# Service Information

Category <b>P</b>	<b>Repair Guidance</b>	Ref. No. R052/16 <b>C</b>	Page 1 of 6
Coverage <input type="checkbox"/> Distributor only <input checked="" type="checkbox"/> Please inform your dealers		Date Issued June 20, 2016	
Please convey this information to your <input checked="" type="checkbox"/> Warranty Dept. <input checked="" type="checkbox"/> Parts Dept. <input checked="" type="checkbox"/> Training Dept. <input checked="" type="checkbox"/> Field Rep.	<input type="checkbox"/> Director <input checked="" type="checkbox"/> General Manager	Date Revised February 24, 2017	
Applicable Model  CX-5 (KE) with Electric Parking Brake (EPB)	Applicable Countries or Specifications  Worldwide

**REVISED**

## Subject: Noise from REAR BRAKE/Trace of Rear Brake Dragging

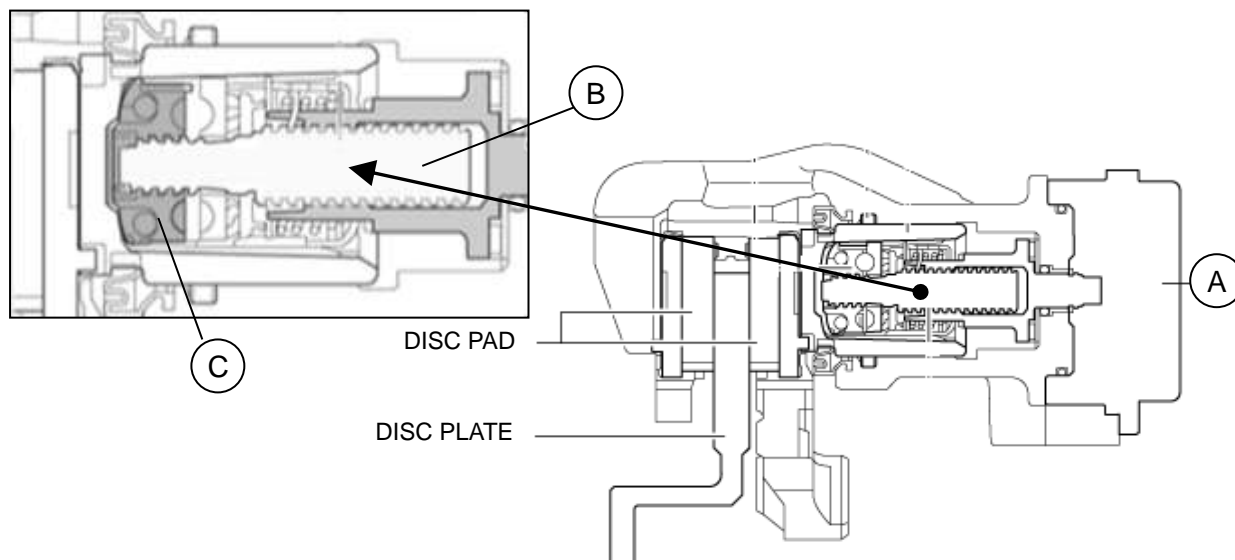
**This concern is caused by the EPB being not completely released.**

**The EPB control module judges that the parking brake is completely released when the current value flown to the motor (A) drops to the threshold, namely when the rotating torque of the spindle (B) drops.**

**Due to insufficient accuracy of the screw threads of the ball and ramp (C), the spindle (B) may idle momentarily during the EPB release operation causing the spindle rotating torque (the current value to the motor) to drop to the threshold before completely releasing the parking brake.**

The ball and ramp has been modified to improve the accuracy of screw threads.

PARTS LOCATION (Sample: CX-5)

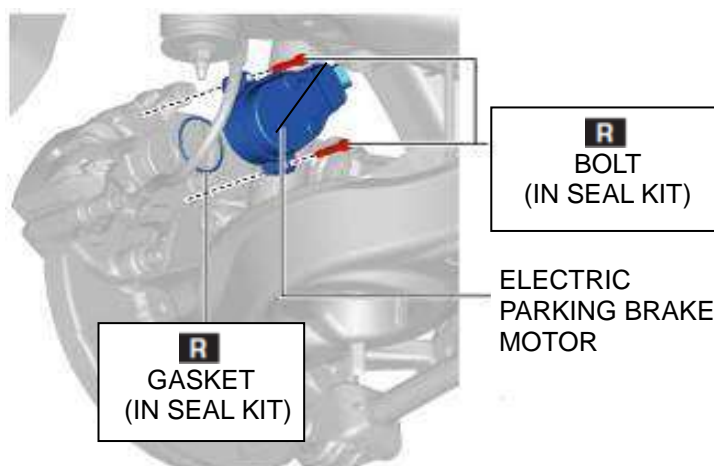
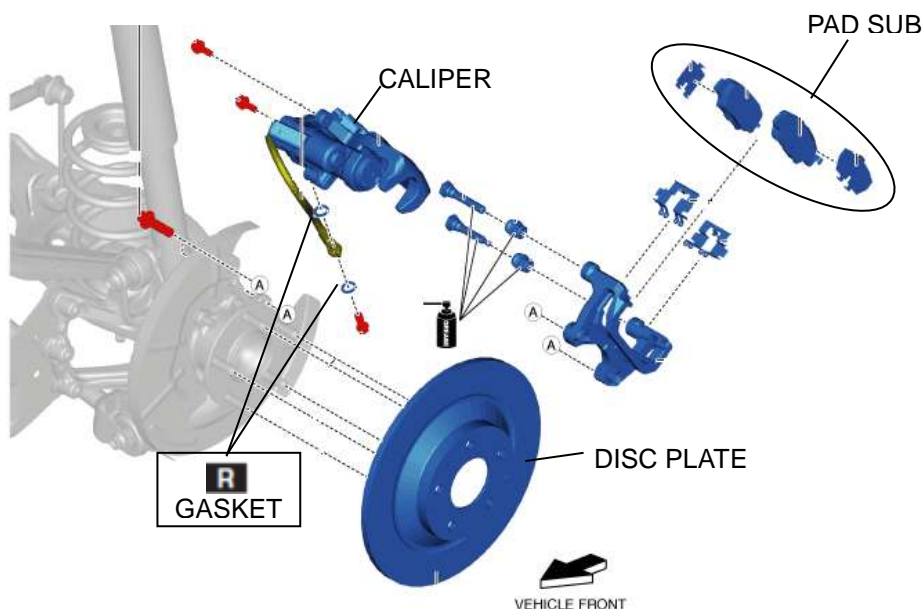
**NOTE:** Part numbers of caliper have not been changed by this modification. Distinguish the modified one from old one using the 3-digit lot number (Production Date) stamped on the caliper. Calipers with the lot number (production date) of 697 (2016/09/07) and higher are modified.
